CITY OF SACRAMENTO
1231 I Street, Sacramento, CA 95814

Site Address: 6711 TRUDY WY SAC
Parcel No: 030-0382-011

Nature of Work: REROOF T/O 38SQ INSTALL LIGHT WEIGHT TILE

Subject: Structural Investigation Report of the Roof for the Residence located at 6711 Trudy Way,
Sacramento, CA 95831.

1 ROOF PLAN - MATSUNAGA
Not to Scale

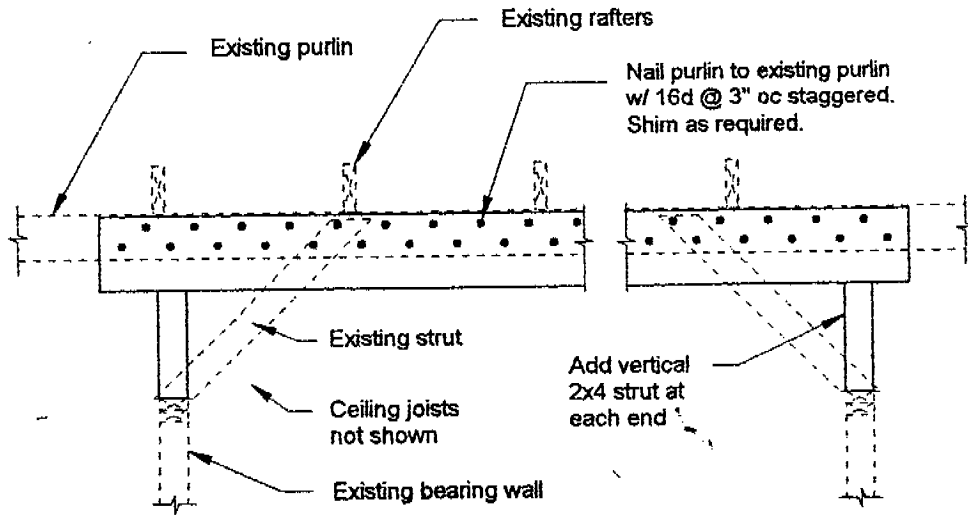
Everything But LVL on Structural OK

PER CONVERSATION
W/ PAUL ZACHER,
SUBSTITUTED FROM
SIMILAR PROJECT
Julian
10/5/00
